CITY OF STAR

LAND USE STAFF REPORT

FILE(S) #: FP-24-02, Final Plat, Naismith Commons Subdivision Phase 3

Proposed Landscaping of N/E Park

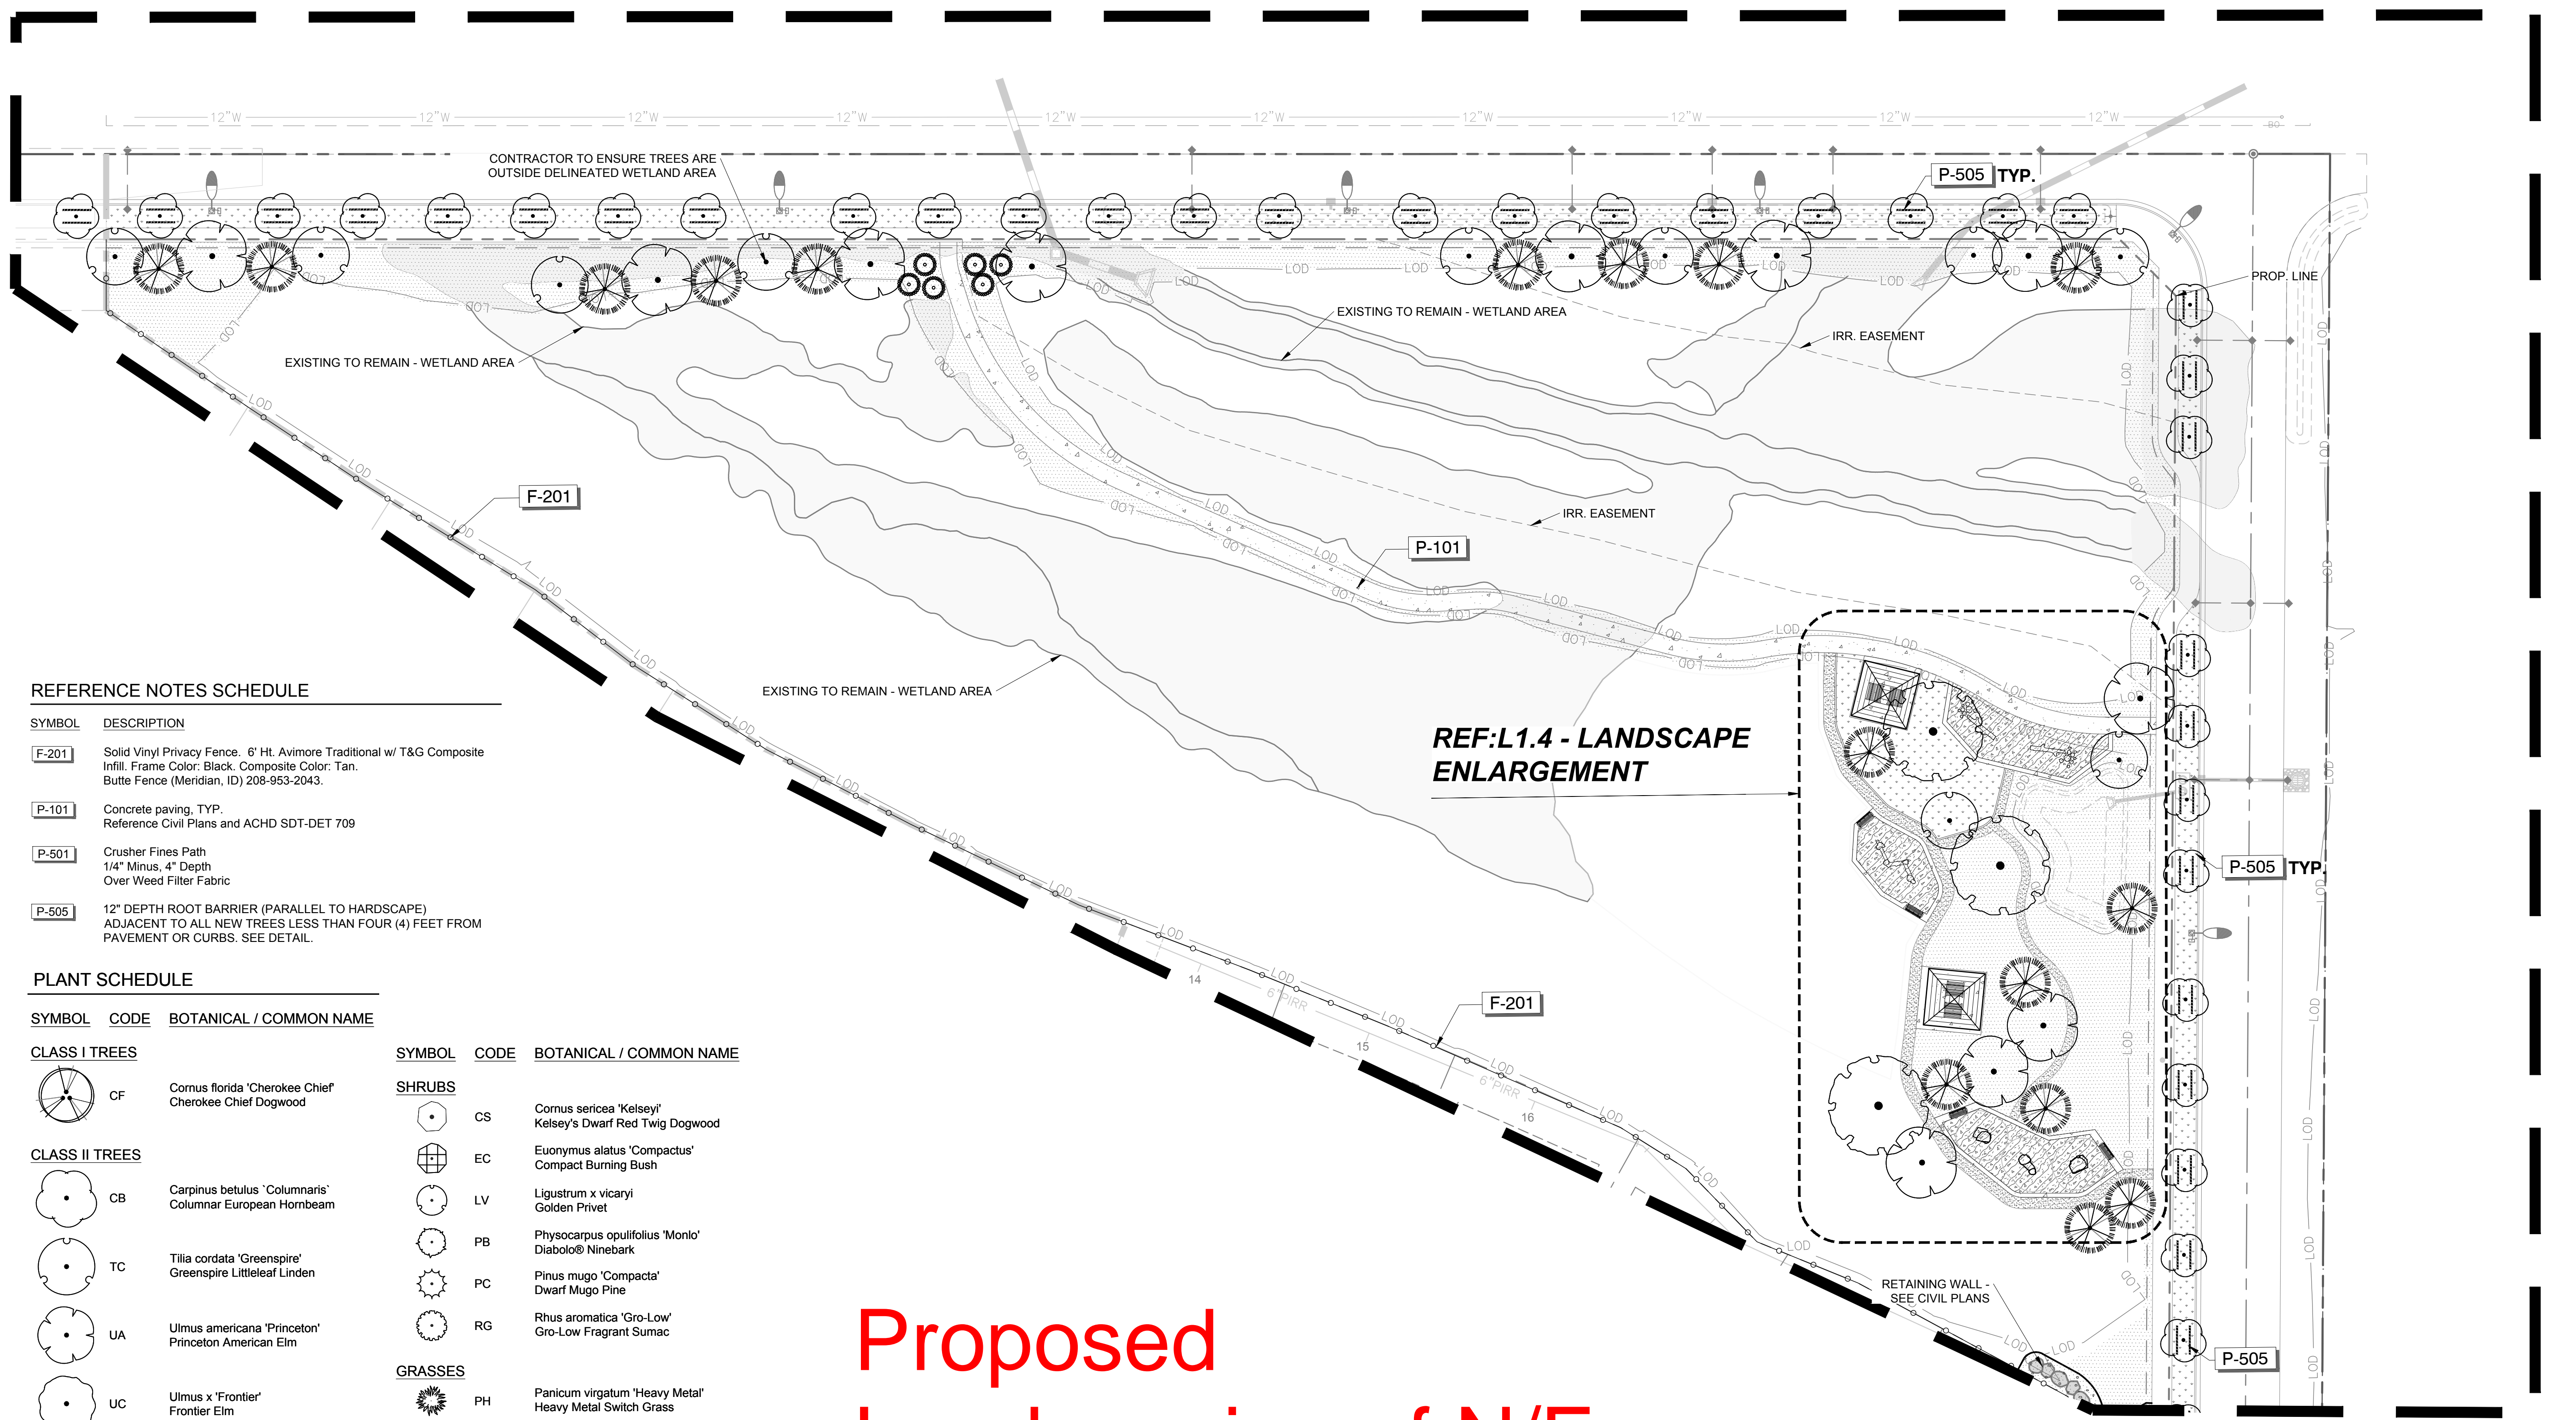
The landscaping and amenities within the park located in the northeast corner of the site do not match the approved landscape plan that was part of the preliminary plat. The applicant shall provide the City Council and Staff with an explanation of why the plan is different in design from what was approved. A revised preliminary plat may be required.

- G. Provide a public access easement on the pathways located in the northeast common area park.**
 - H. Applicant shall provide written documentation for City to take over ownership of southwest park in the future. The recorded CC&R's shall recognize this, and a copy shall be provided to Staff.**
